ACCESS REPORT

DEVELOPMENT APPLICATION

CHURCH POINT CARPARK

16TH NOVEMBER 2015

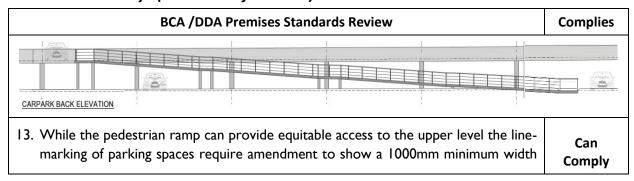
12.	The design proposes two stairways on the western side of the car park structure and a 1:14 pedestrian ramp on the eastern side. See the section below regarding detailing of the stairs and ramp.	YES at CC stage

BCA /DDA Premises Standards Review	Complies
accessway between car spaces that has level access to the top ramp landing, which indicates 1540mm X 1200mm. Similarly, details of the bottom landing and access between cars is required to confirm a compl8iant access path.	
350x2600 6	*
200	1.
1mHIGH CONCRETE 600x350 COLUMN UPSTAND	*

14. The 1200mm minimum width will enable the installation of handrails to achieve the required 1000mm minimum clearance specified by AS1428.1 to satisfy D3.3 of the BCA and DDA Premises Standards.	YES

15. The design also illustrates a 1800mm width X 2000mm length Passing Bay consistent with AS1428.1 to satisfy Part D3.3 of the BCA and DDA Premises Standards.	YES

16. However, in my opinion the minimum clearance between handrails should be 1500mm to enable Passing by a person with a pram and a wheelchair user or two ambulant people.	Advisory
